Well Name: JAMES RANCH UNIT DI 7 SAWTOOTH

Well Number: 117H

Notice of Intent

Type of Action: APD Change

WELL LOCATION AND ACREAGE DEDICATION PLAT

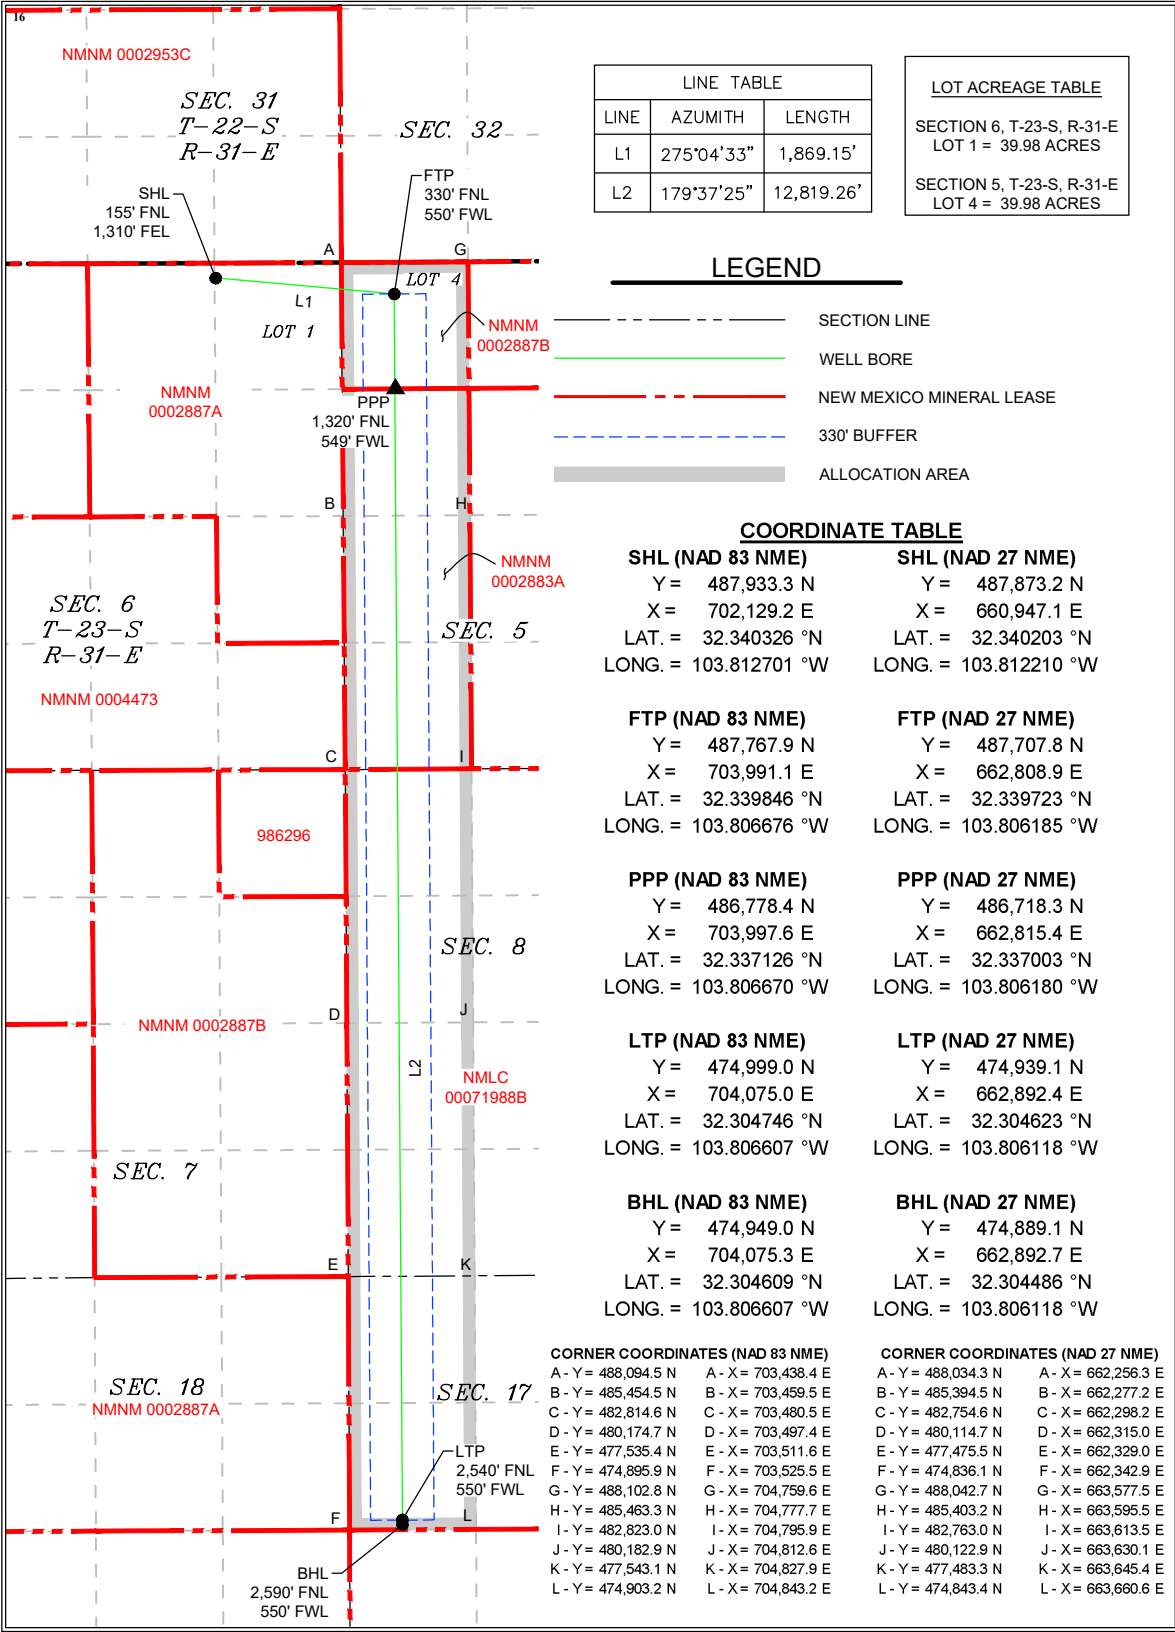
Procedure Description: XTO Permian Operating LLC respectfully requests approval to make changes to the approved APD as follows: SHL, FTP, LTP, BHL, proposed total depth (MD & TVD) and pool change. FROM: TO: SHL: 155' FNL & 1960' FEL of Section 6-T23S-R31E 155' FNL & 1310' FEL of Section 6-T23S-R31E FTP: 700' FSL & 550' FEL of Section 31-T22S-R31E 330' FNL & 550' FWL of Section 5-T23S-R31E PPP 1-2: 1320' FSL & 555' FEL of Section 6-T23S-R31E 1320' FNL & 549' FWL of Section 5-T23S-R31E PPP 1-3: 0' FNL & 556' FEL of Section 7-T23S-R31E PPP 1-4: 1320' FNL & 556' FEL of Section 7-T23S-R31E LTP: 2540' FNL & 550' FEL of Section 18-T23S-R31E 2540' FNL & 550' FWL of Section 17-T23S-R31E BHL: 2590' FNL & 550' FEL of Section 18-T23S-R31E 2590' FNL & 550' FWL of Section 17-T23S-R31E The proposed total depth will change from 25641' MD; 11324' TVD (Wolfcamp) to 24159' MD; 11267' (Wolfcamp). The Pool will change from Los Medanos; Wolfcamp, South to Sand Dunes; Wolfcamp. ATTACHMENTS: C-102 and Directional Plan

The proposed total depth will change from 25641 MD; 11324 TVD (Wolfcamp) to 24159 MD; 11267 (Wolfcamp). The Pool will change from Los Medanos; Wolfcamp, South to Sand Dunes; Wolfcamp.

¹ API Number 30-015- 54883	² Pool Code 96991	³ Pool Name SAND DUNES; WOLFCAMP
⁴ Property Code 333473	⁵ Property Name JRUI 7 SAWTOOTH FED COM	⁶ Well Number 117H
⁷ OGRID No. 373075	⁸ Operator Name XTO PERMIAN OPERATING, LLC	⁹ Elevation 3,329'

¹⁰ Surface Location									
UL or lot no.	Section	Township	Range	Lot Idn	Feet from the	North/South line	Feet from the	East/West line	County
1	6	23 S	31 E		155	NORTH	1,310	EAST	EDDY

¹¹ Bottom Hole Location If Different From Surface									
UL or lot no.	Section	Township	Range	Lot Idn	Feet from the	North/South line	Feet from the	East/West line	County
E	17	23 S	31 E		2,590	NORTH	550	WEST	EDDY
